MILITARY SPECIFICATION

MICROCIRCUITS, LINEAR, CMOS, ANALOG SWITCH WITH DRIVER,

MONOLITHIC SILICON

This amendment forms a part of Military Specification MIL-M-38510/116, dated 16 April 1980, and is approved for use by all Departments and Agencies of the Department of Defense.

Device type 01

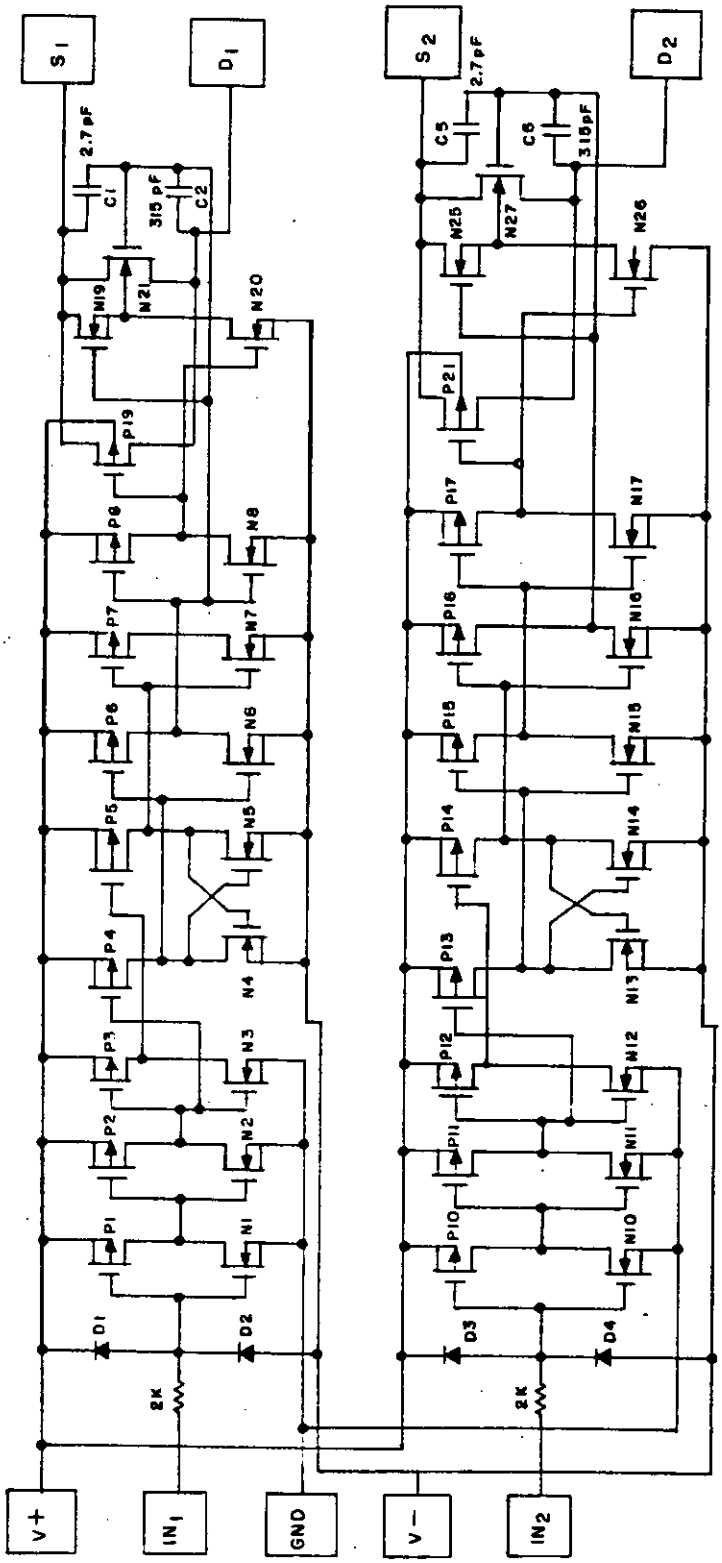
* FIGURE 4: Delete schematics for device types 01 and 02 and substitute new schematics as shown on pages 8 and 9 of this amendment. (Device 02 schematic reprinted without change from amendment 4).

Device type 03

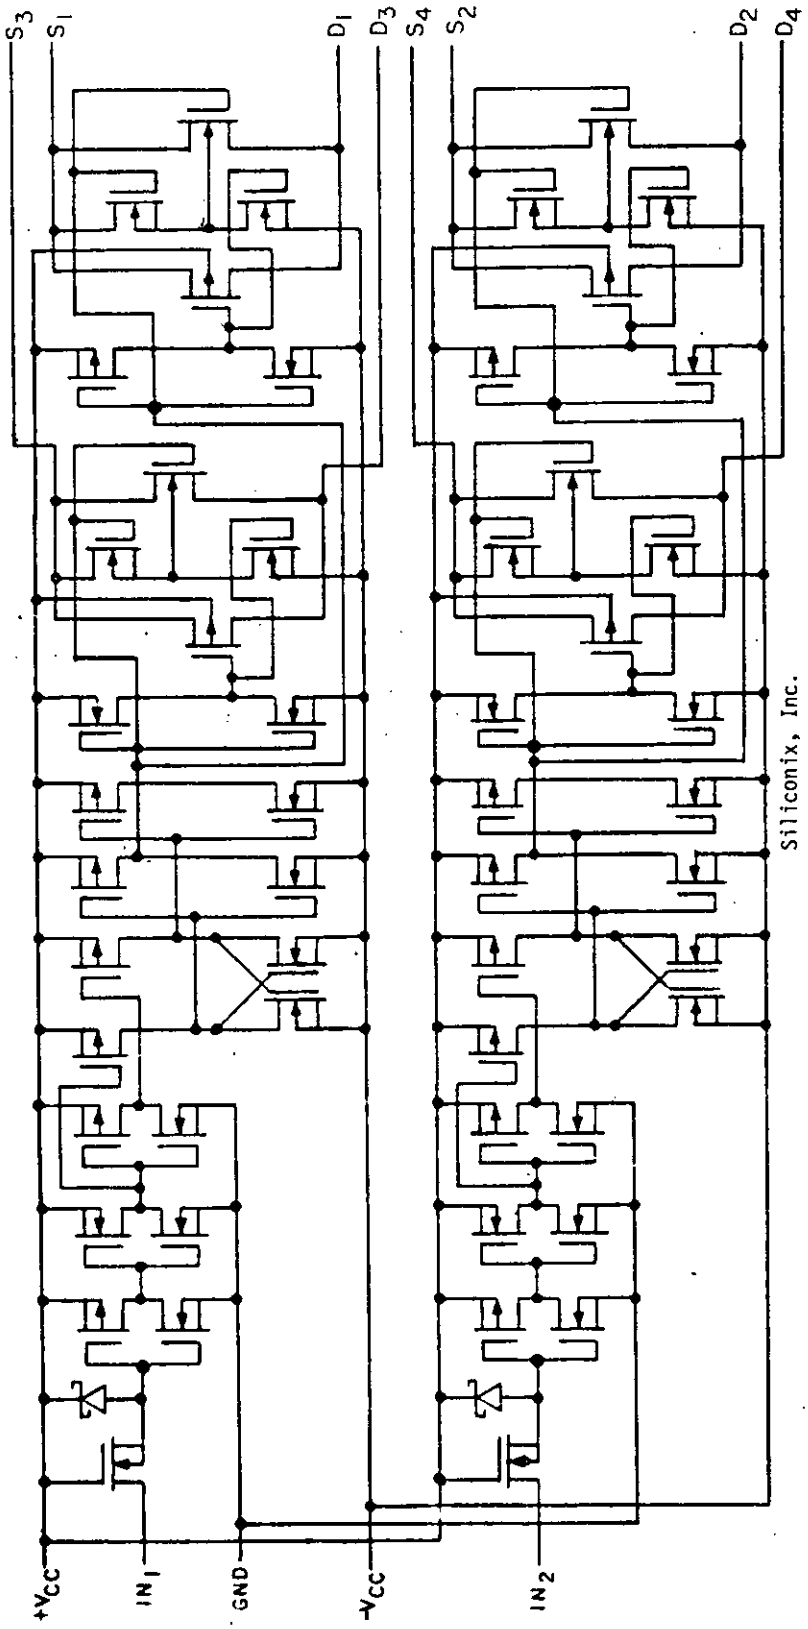
FIGURE 4: Delete schematic for device type 03 and substitute new schematic as shown on page 10 of this amendment.

Device type 04

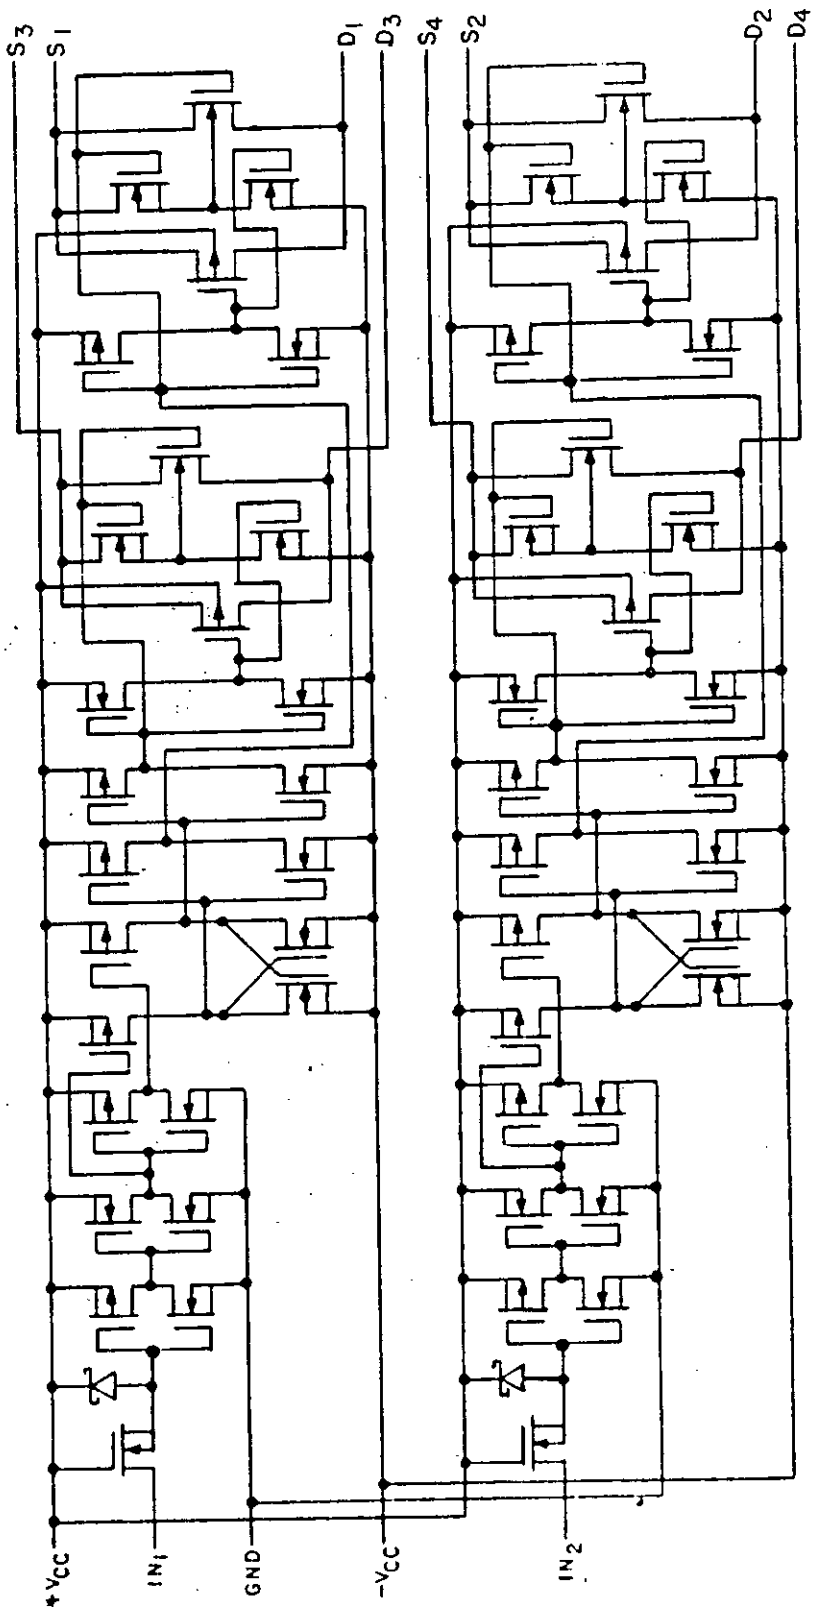
FIGURE 4: Delete schematic for device type 04 and substitute new schematic as shown on page 11 of this amendment.

FIGURE 4. Schematic circuit - Continued.

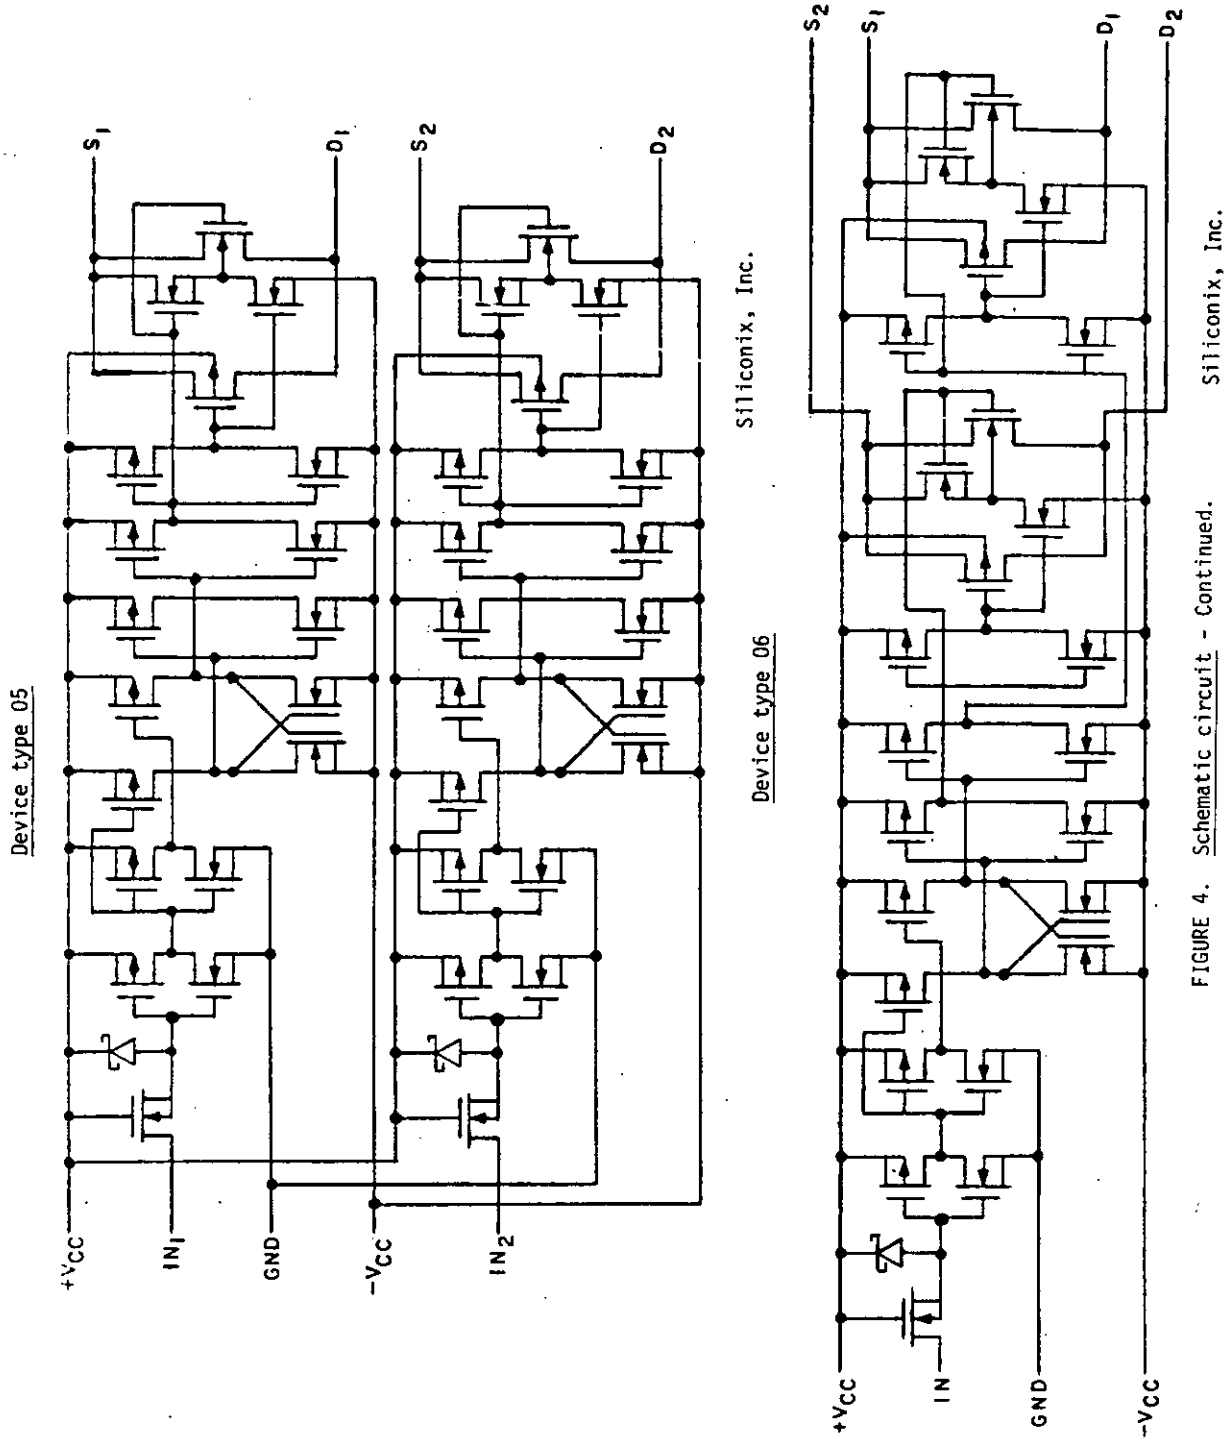
FIGURE 4: Delete schematics for device types 05 and 06 and substitute new schematics as shown on page 12 of this amendment.

Device type 07

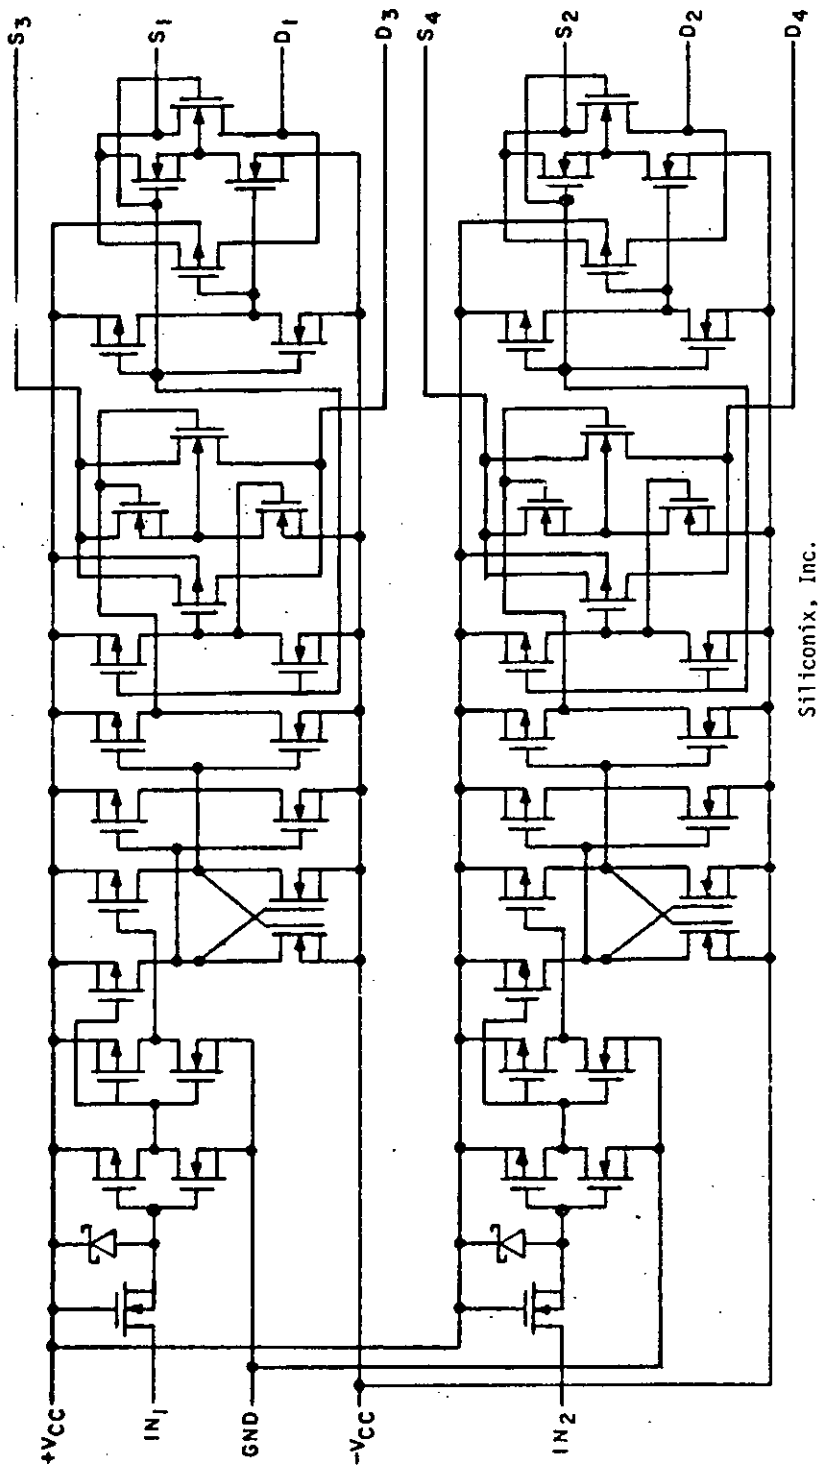
FIGURE 4: Delete schematic for device type 07 and substitute new schematic as shown on page 13 of this amendment.

Device type 08

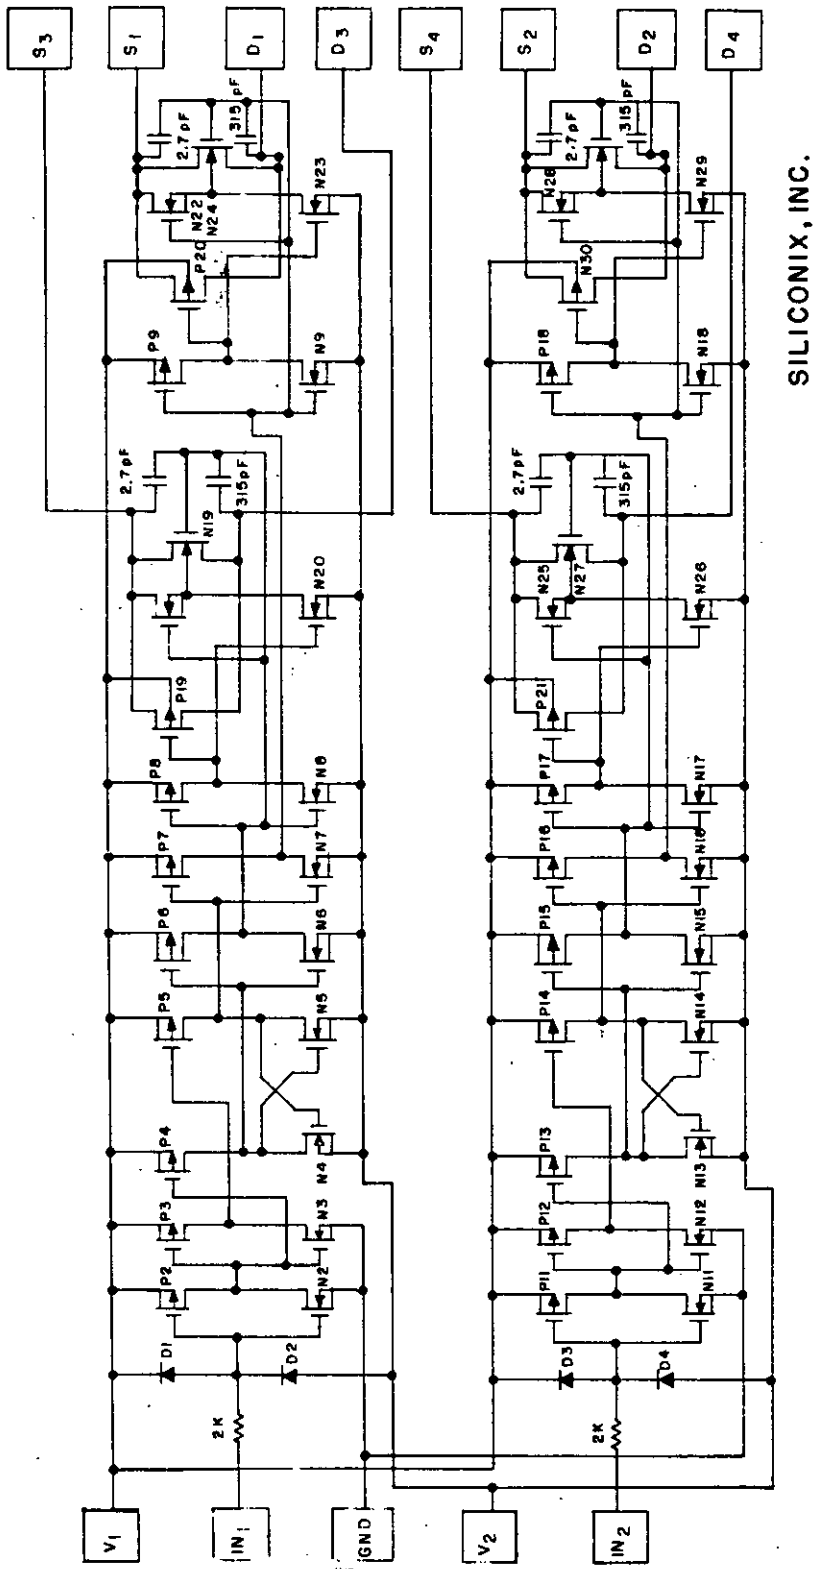
* FIGURE 4: Delete schematic for device type 08 and substitute new schematic as shown on page 14 of this amendment.

FIGURE 14. Charge transfer error test circuit.

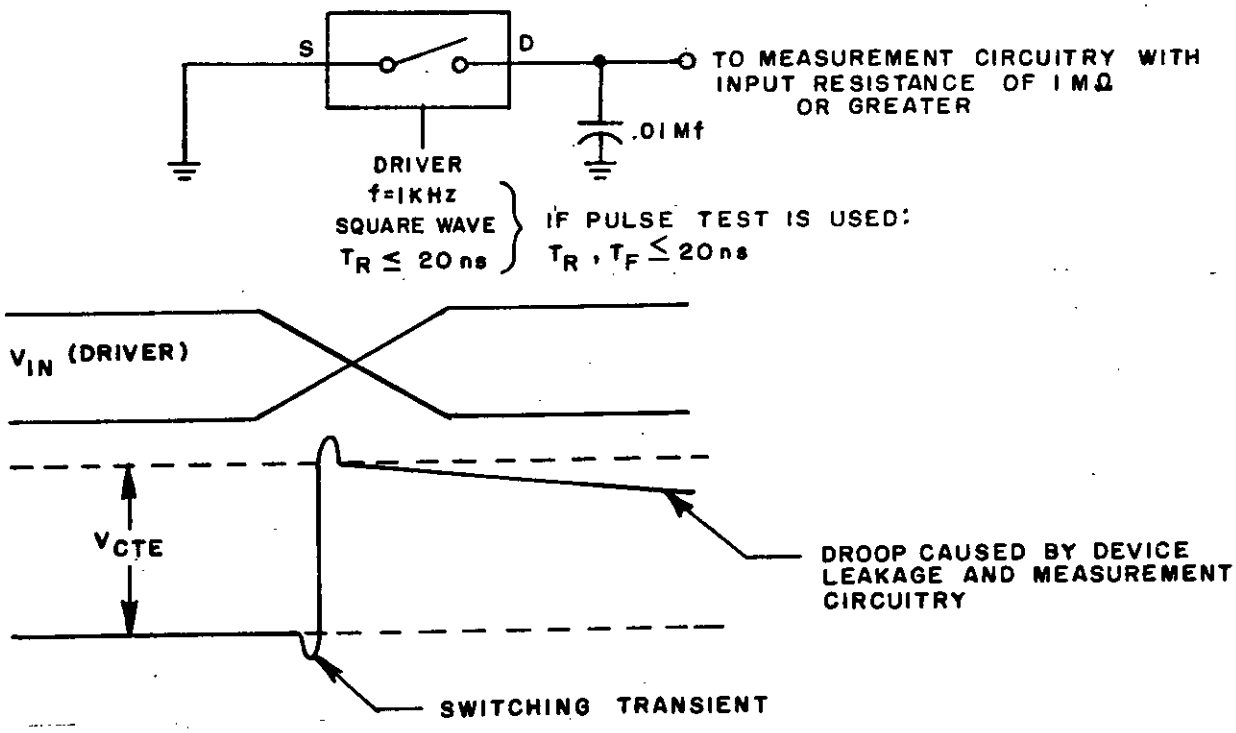
* FIGURE 14: Delete and substitute new figure as shown on page 15 of this amendment.
